**ADDENDUM NO. 04**

Issued: May 8, 2020

Project: Maintenance Offices Exterior Circulation Repair  
2220 N. 59th Street, Kansas City, Kansas 66104

Project No. 18002

**K5** Scale 3/4" = 1'-0" Section 3

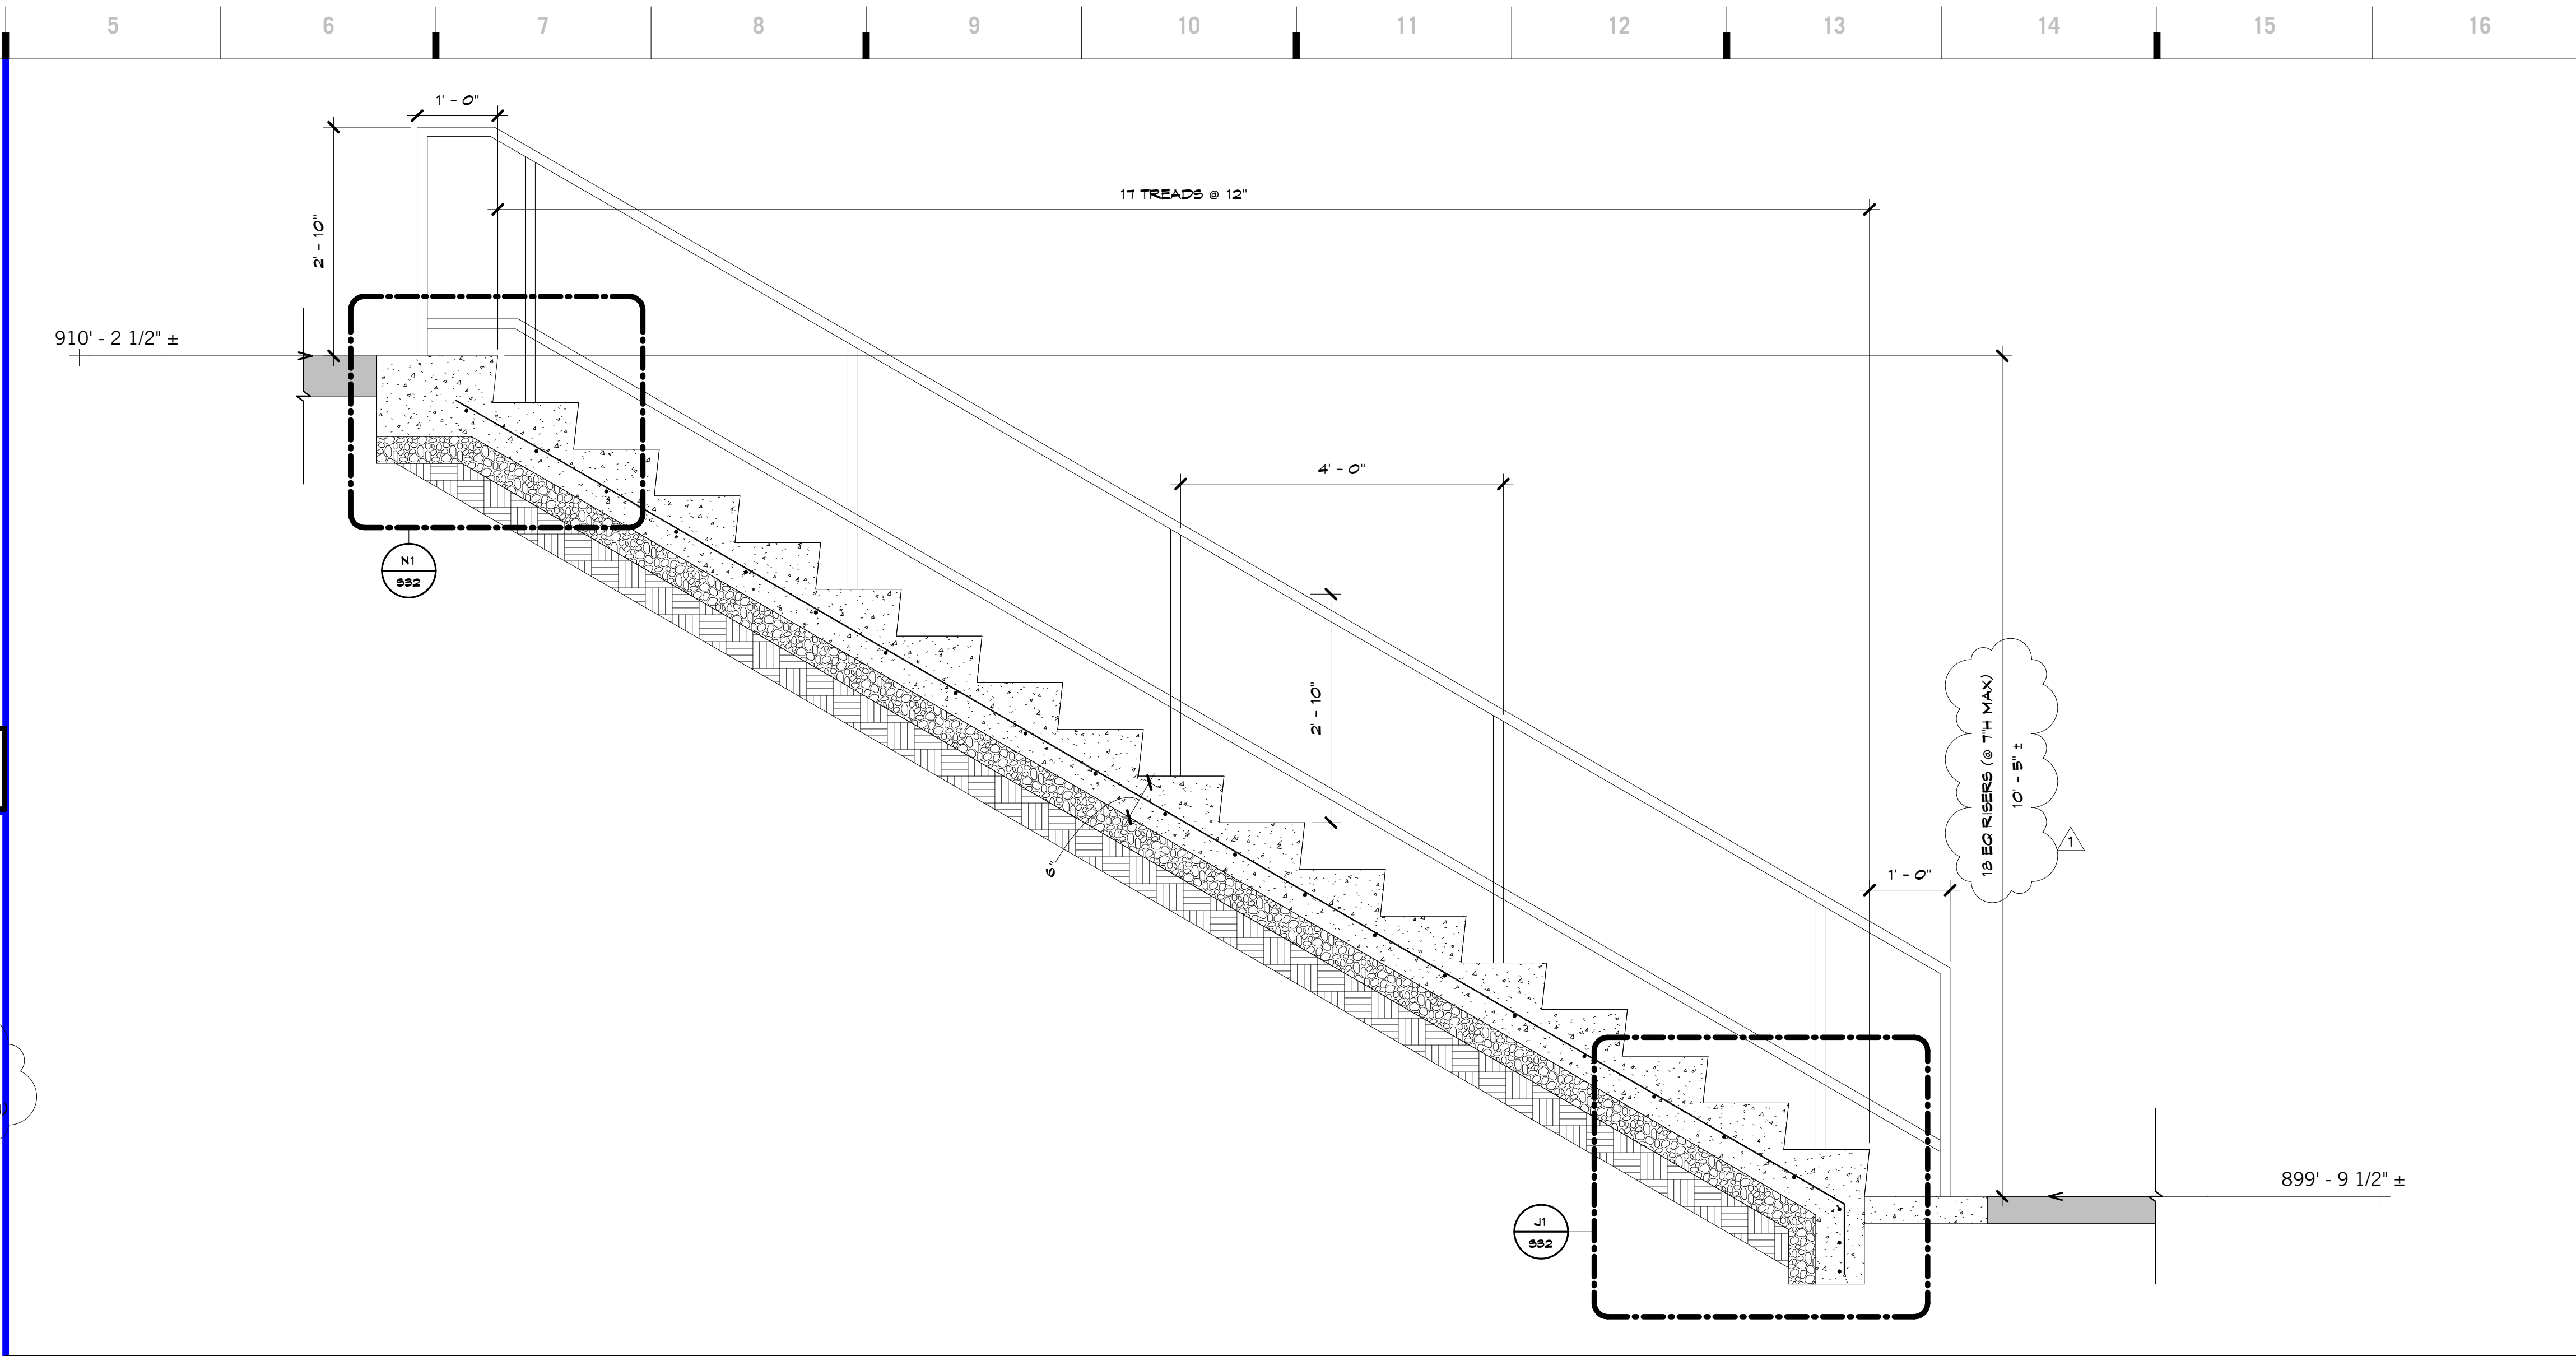
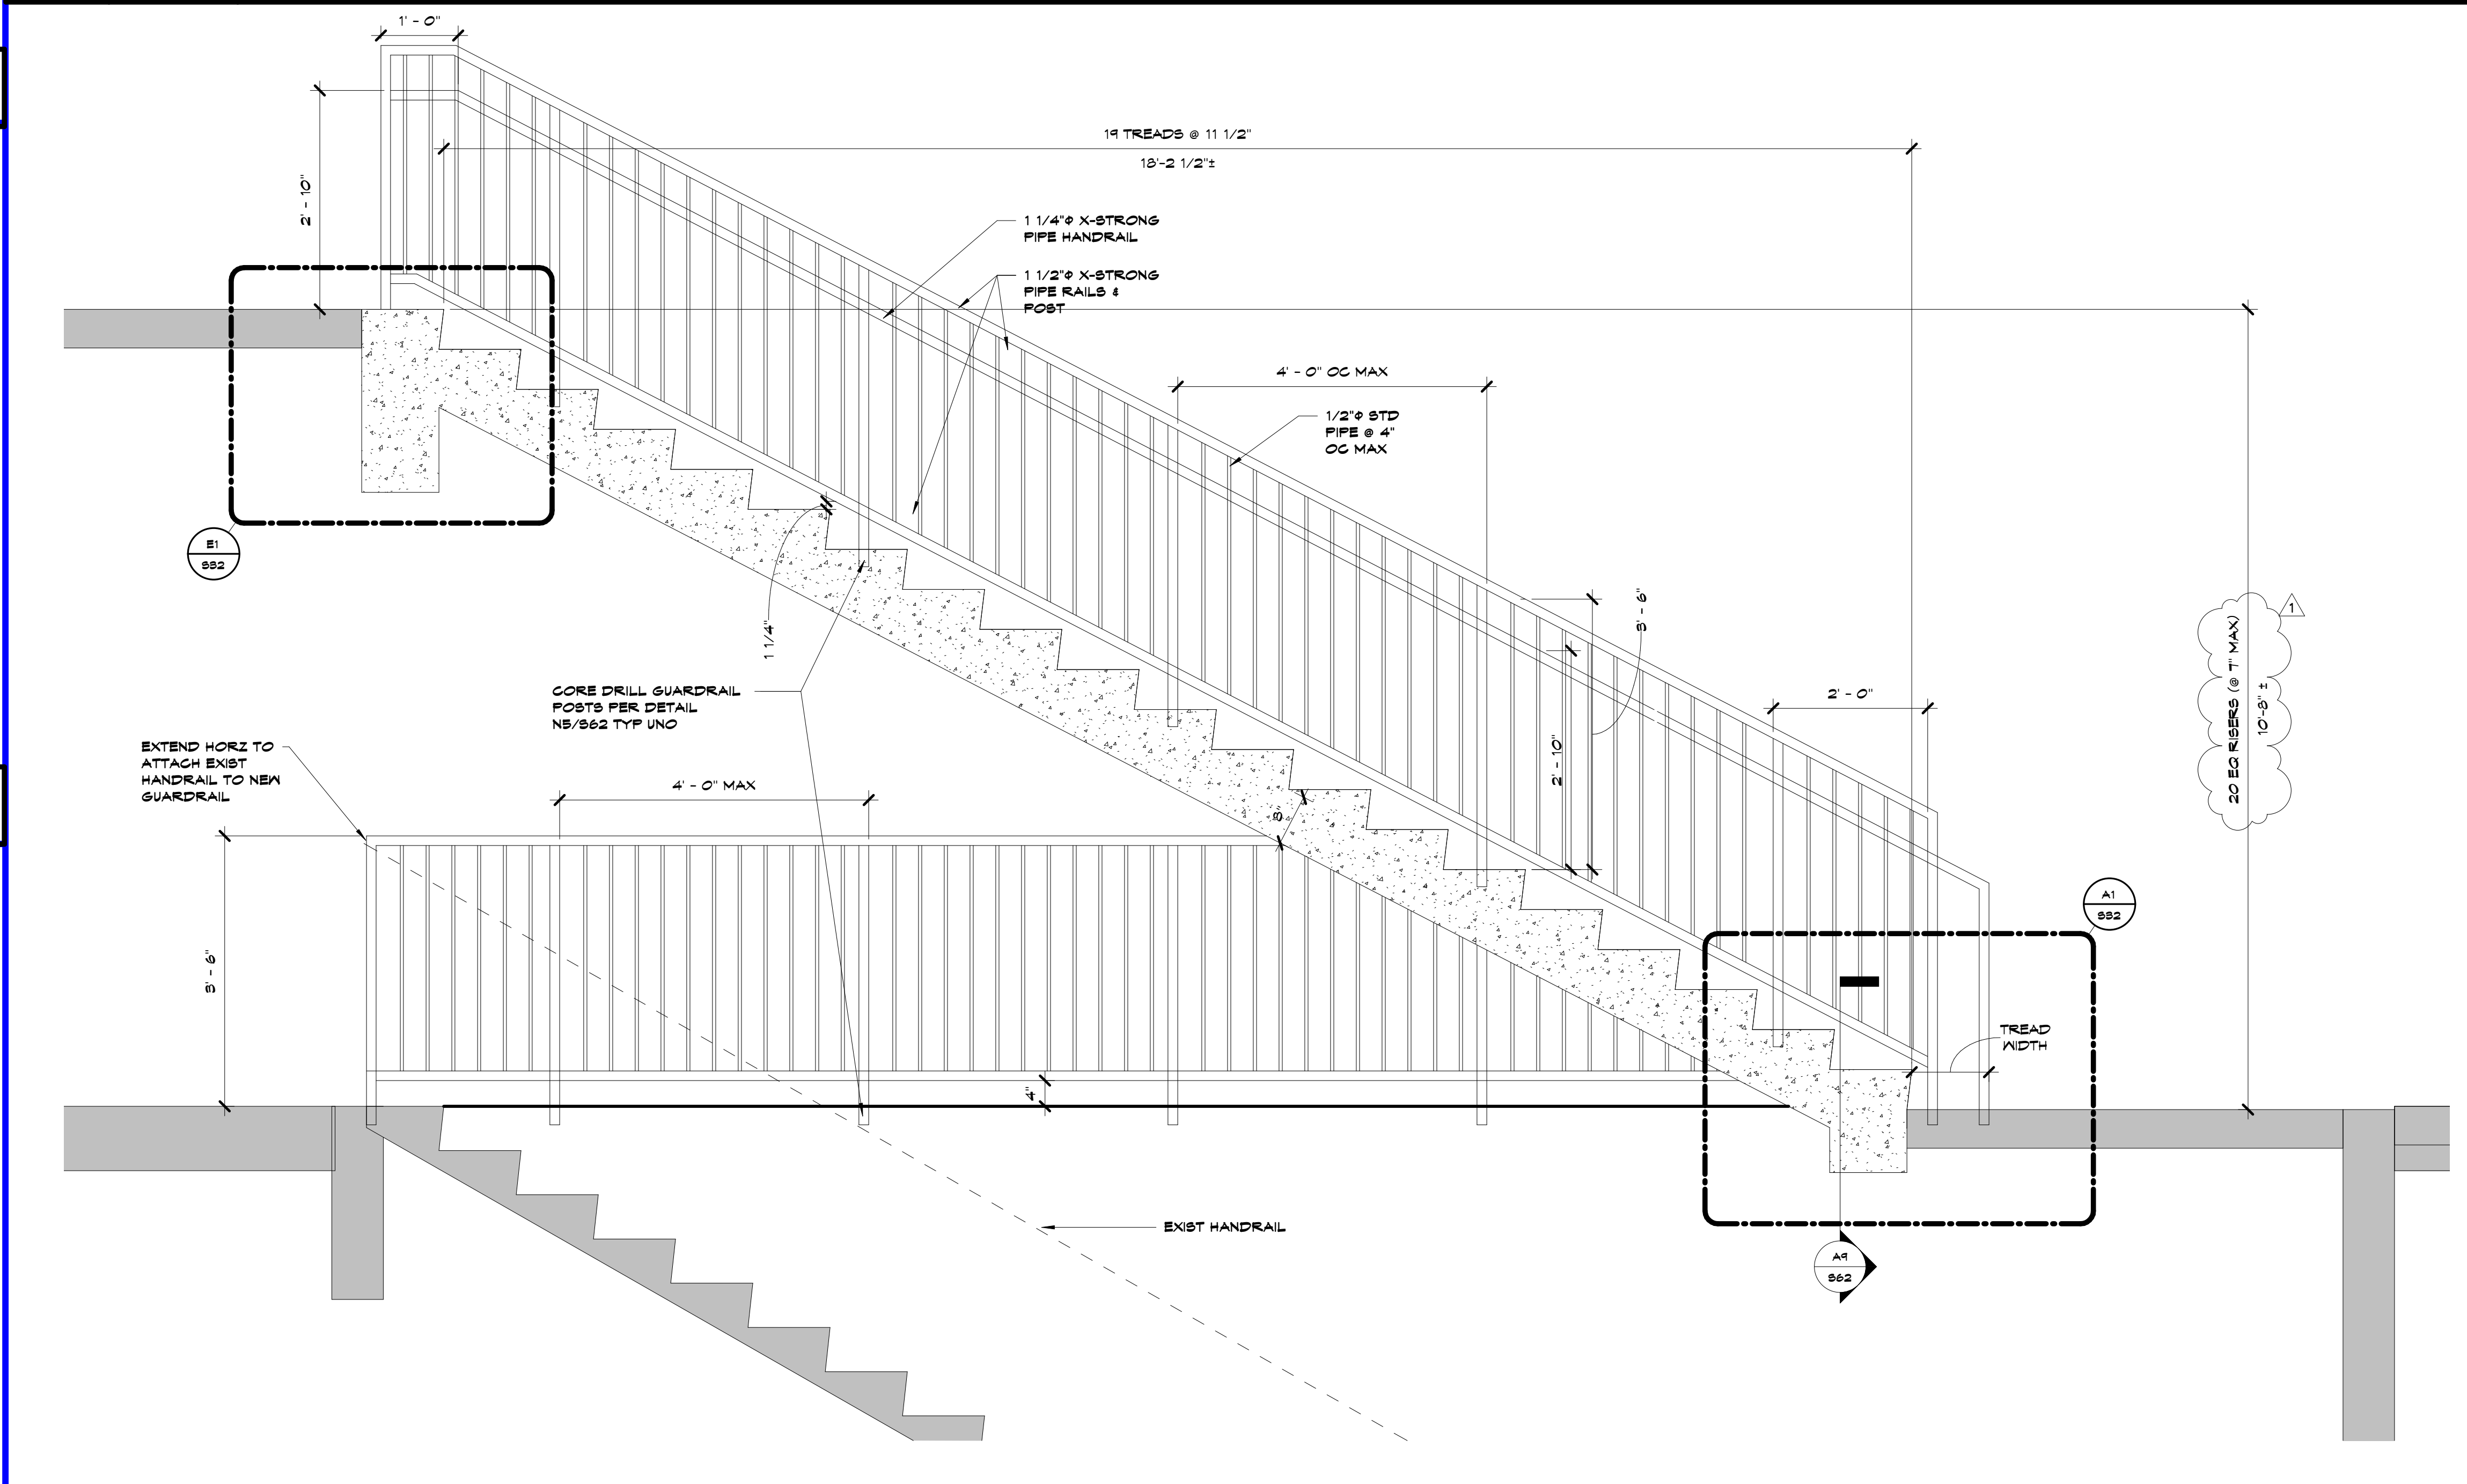
Steel	Bid Set 20200415	Per S04, section K5/S32 reference stair replacement. Are both stairs on grade scheduled for replacement?	Builders Steel	2	Confirmed.
Steel	Bid Set 20200415	Per S05, is the intent for the rails to be continuous on each side of the (2) bridges? Section N13/S62 does not show the rail. The rail is shown per N9/S62.	Builders Steel	2	Rails to be continous to match existing conditions at bridge. Section N13/S62 is a typical slab section.
Steel	Bid Set 20200415	Please confirm the alternate rail on level 1 should be figured as alternate #2. Elevation A9/S61 is noted alternate #3.	Builders Steel	2	Confimed; rail alternate is incorrect on A9/S61. Alternates to match descriptions on cover sheets.
